APPROVED MEETING MINUTES

January 7, 2016

U District Station

Design Development

Figure 4: Proposed TOD development

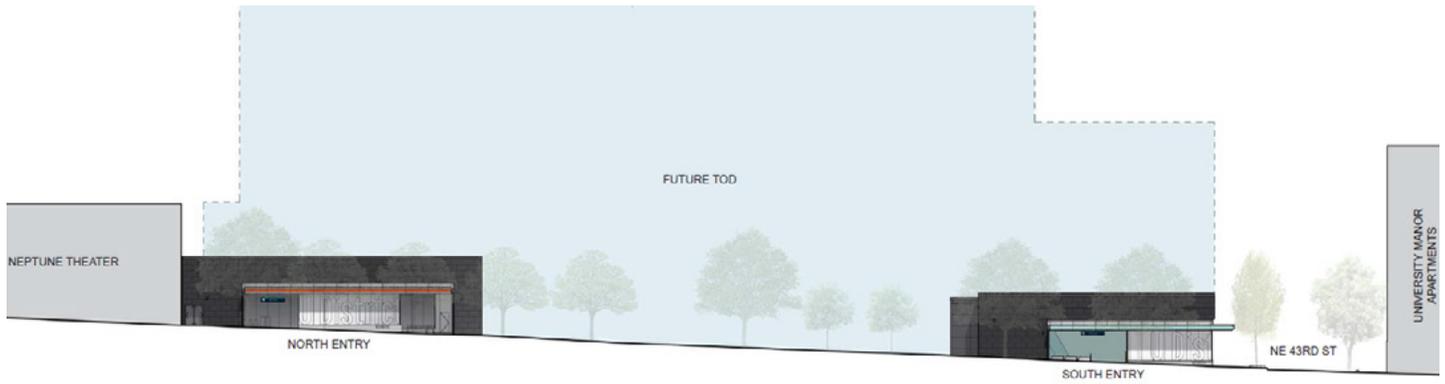
The Panel commended the design team for accommodating TOD on top of both station entrances and the station box. LRRP agrees the materials used on the façade of the station will help anchor the entrances on each end of the future development. Because the TOD will be developed after the station opens, the panel recommends the design team think about properly screening the undeveloped parcel as well as minimizing the station mechanical elements that are visible from the street.

1. If advertising is included at the station, return to the LRRP for an administrative review of the locations and design features.
2. If the TOD site will not start construction within 3 months following completion of station construction, return to the LRRP for an administrative review of how the TOD site will be screened.

1. The TOD site should consider using building setbacks to highlight UDS station entrances
2. Minimize views and appearance of any rooftop mechanical equipment, including any penthouse, if such features are required in the interim between station and TOD development
3. Better integrate the signage board at the center of the station platform with the aesthetic design of the overall station
4. Consider and, where needed, adjust the size and orientation of artwork digital screens to ensure they can be viewed from various points within the station
5. Provide physical context to the isolated artwork video monitors to better incorporate them within the overall art concept
6. Minimize and integrate the advertising program within the station design, if any advertising is to be provided on site

Figure 5: Proposed artwork program

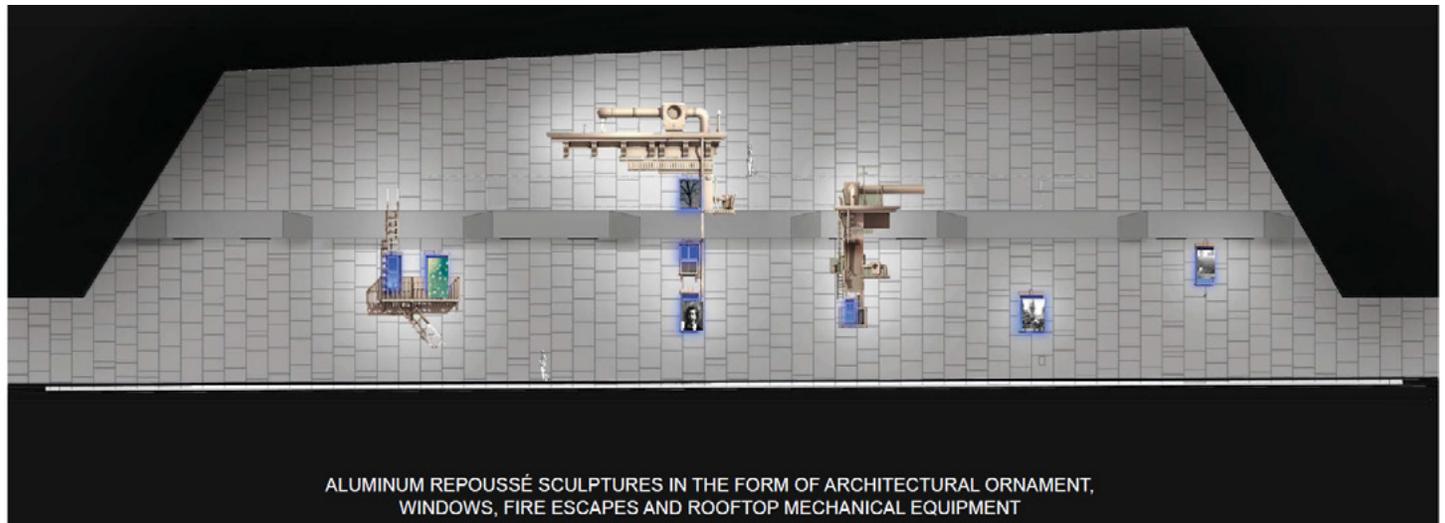
The LRRP recommended the design team make sure the size of the video screens are adequate enough to view from the station platform and mezzanine level. The panel agreed that footage showing cityscapes integrated well with the surrounding artwork. Panel members are concerned that none of the footage for the proposed art installations has been reviewed by LRRP and recommend the project return for an administrative review of the video artwork.
